Prepared for
HYG

Urban Design Review of Planning Proposal 845 Pacific Highway, Chatswood

Issue Reference	Issue Date	Issue Status
A	14/7/2021	Draft
B	21/9/2021	Issue for submission

Figure 4 Study showing fully compliant tower setbacks
Source: PTW Architects

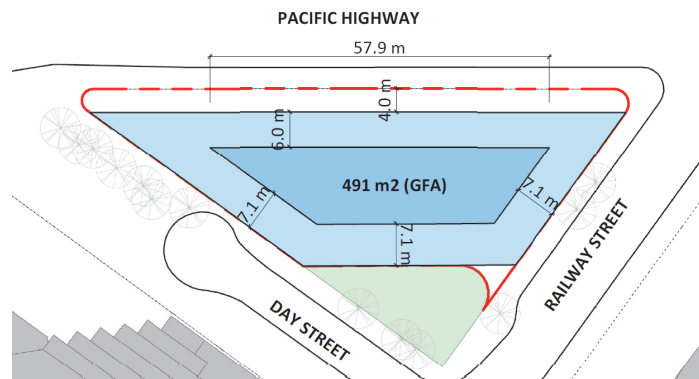
A tower design that is fully compliant with all setback controls achieves a 577sqm Gross Building Area (491sqm GFA) as demonstrated on the diagram below.

From the above, it is clear that a significant office building would not be built on the site if setback controls are enforced rigidly.

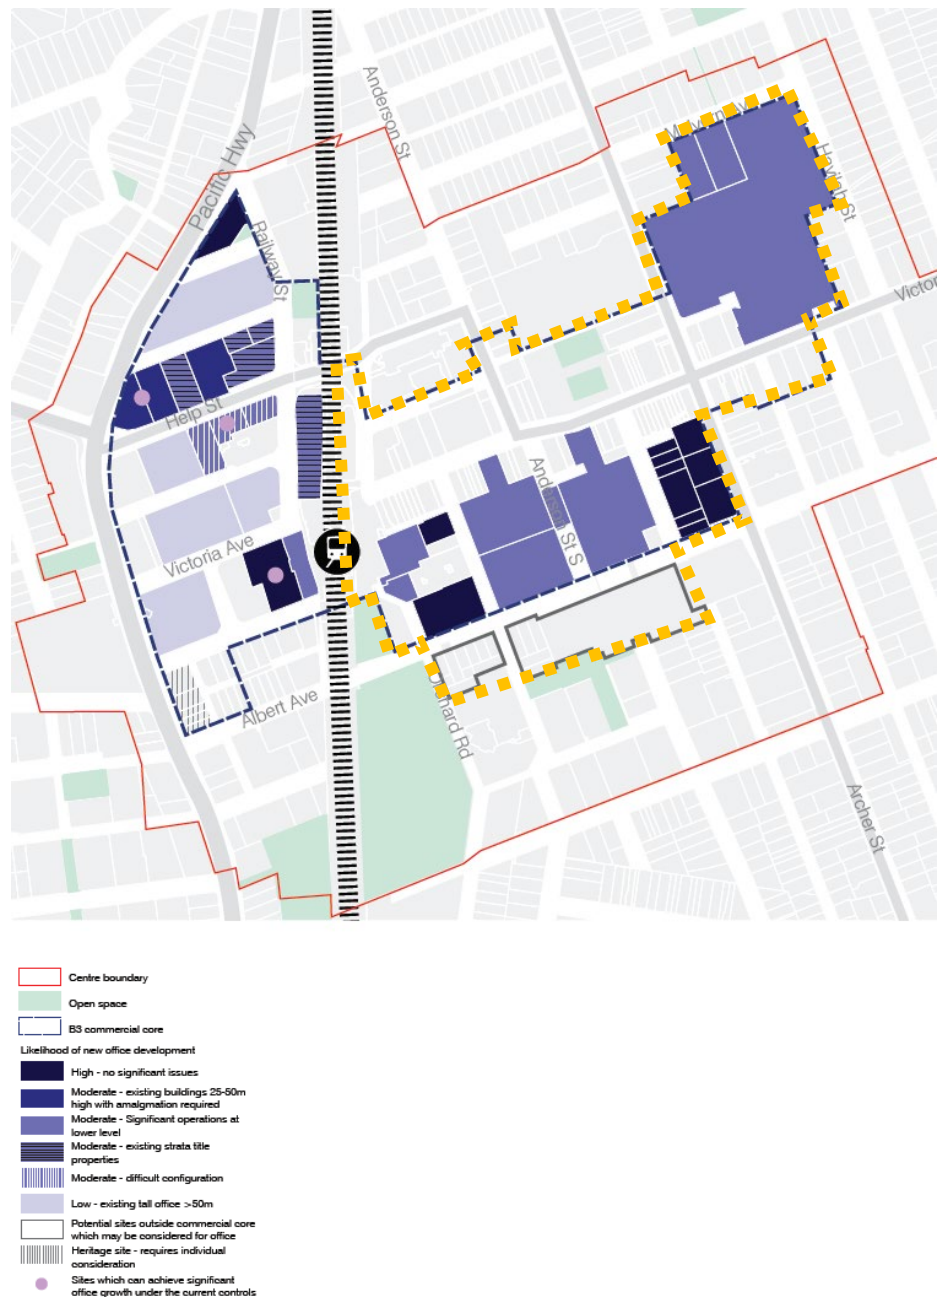
The subject site has been considered part of the office growth for the future of Chatswood as is demonstrated by its inclusion in the original 2016 version of the Chatswood CBD Strategy (see Figure 3 below), developed by Architectus and Council with input from BIS Oxford Economics, where it is noted as one of the least constrained sites for office growth in the CBD. Since Figure 3 was developed the Department of Planning, Industry and Environment has noted the potential for residential development to occur on some sites east of the railway, which may limit office potential on those sites placing greater emphasis on ensuring office development can occur on those west of the railway.

The above considerations leave the subject site and the RSL site close to the railway station as the sites which have been anticipated as the least fundamentally constrained within the Chatswood Office Core. The RSL site is able to redevelop to a significantly greater FSR under the current controls which have been in place for many years and therefore it can be questioned whether the owners would be enticed to redevelop even where further uplift is provided.

Figure 8 Diagram demonstrating distance from neighbouring towers

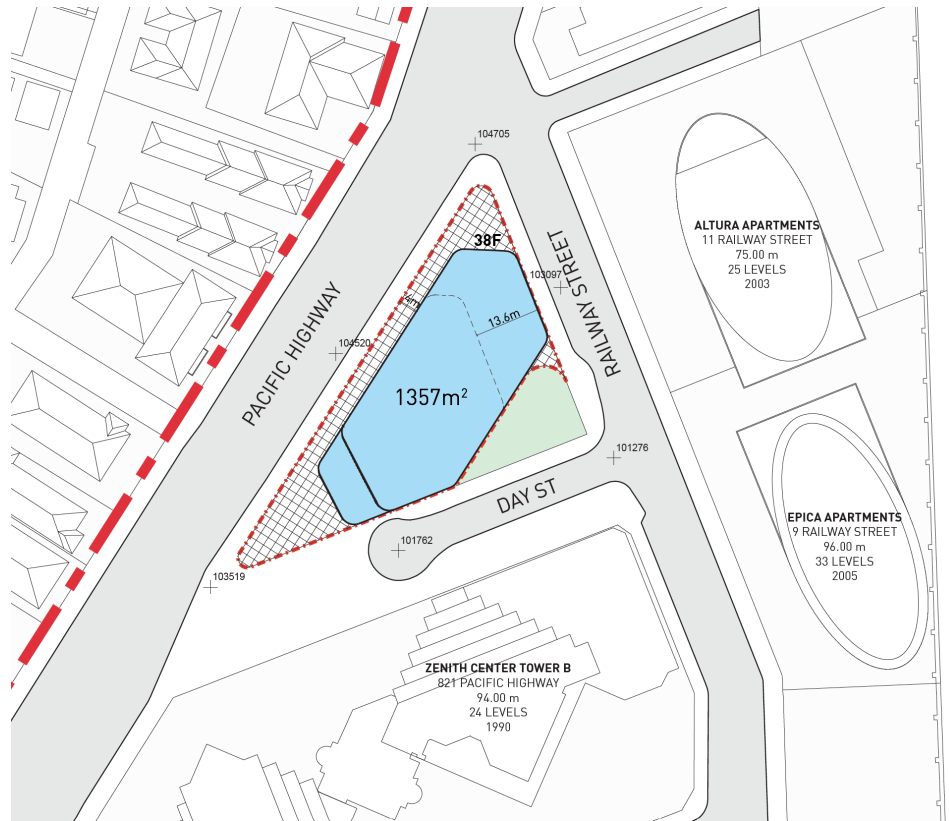
As the site is located on its own street block, it is extremely well separated from neighbouring buildings, approximately 32m to the east to the Altura Apartments and 20m to the south to the Zenith Centre towers at their nearest points. It is not considered that this tower would crowd the centre.

Figure 11 Midwinter solar access to open space – compliant scheme (left) compared to proposed scheme (right)

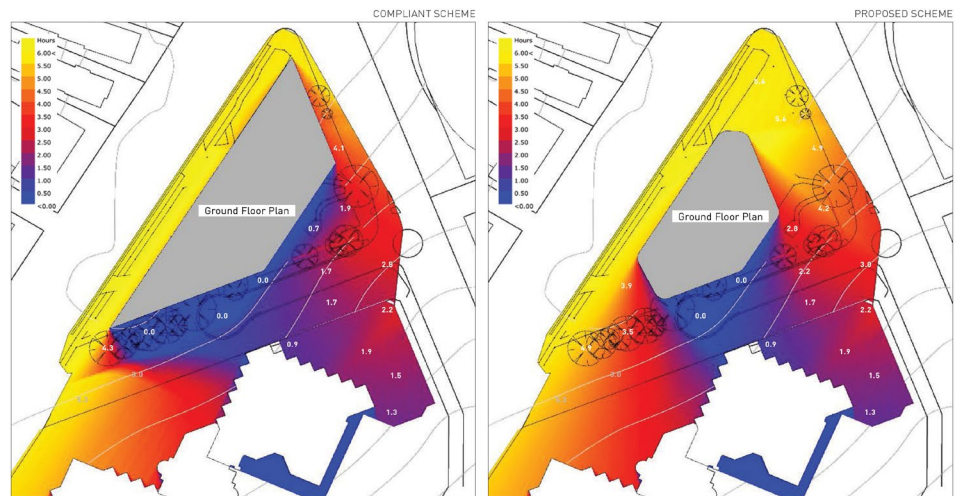
Solar analysis undertaken of the proposal against a fully-compliant scheme demonstrates that there is not only the potential to provide a new space with excellent access to sunlight in midwinter (which few sites can provide in the CBD as this is on its northern edge) but also the potential to increase solar access to Council's existing park. The provision of this new open space is therefore commended.
